0 Summer Street, Weymouth, MA

Issues remaining to be resolved for Conservation include:

SITE PLAN OF LAND  
0 SUMMER STREET  
WEYMOUTH, MASSACHUSETTS

## Cultec Recharger 330XLHD Chamber

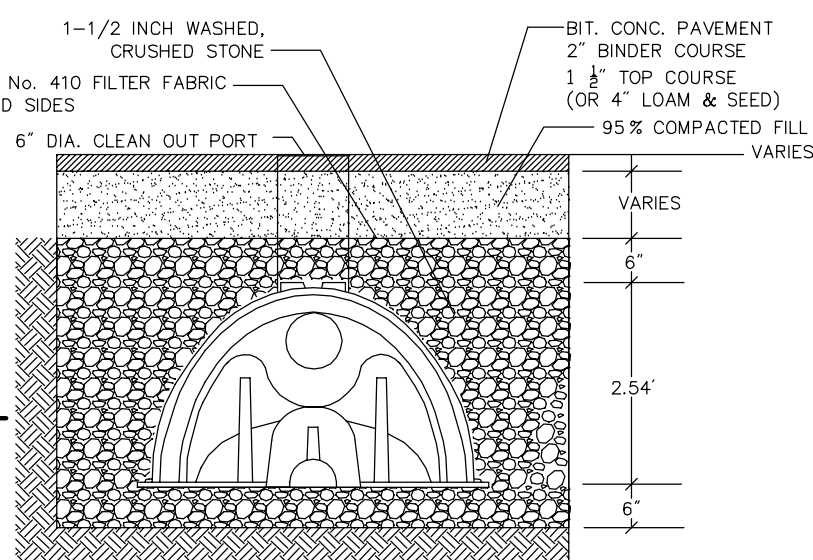
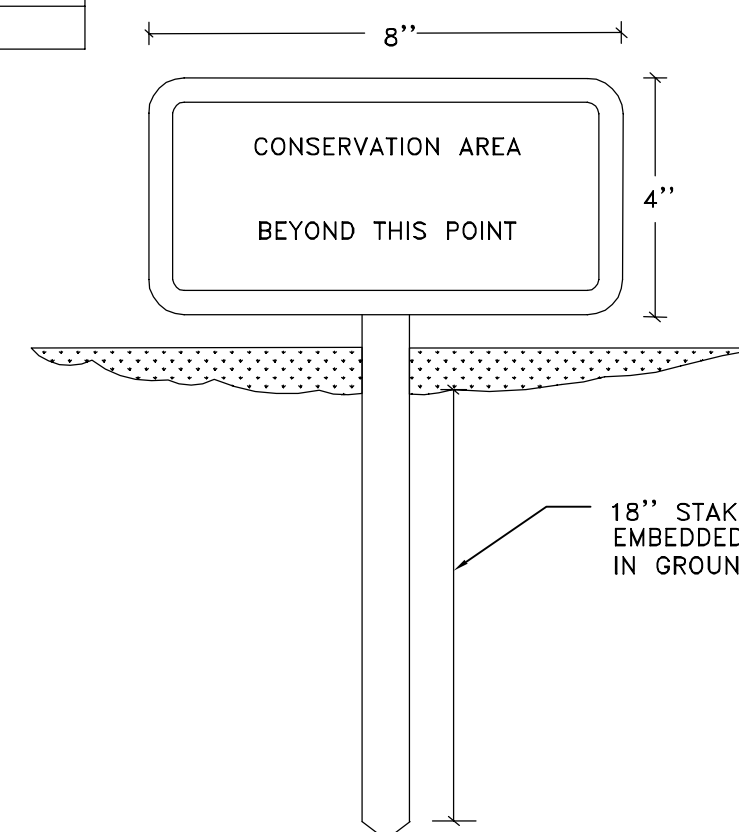
12. Infiltration units for roof runoff.

*Infiltration chambers have been added for roof runoff*
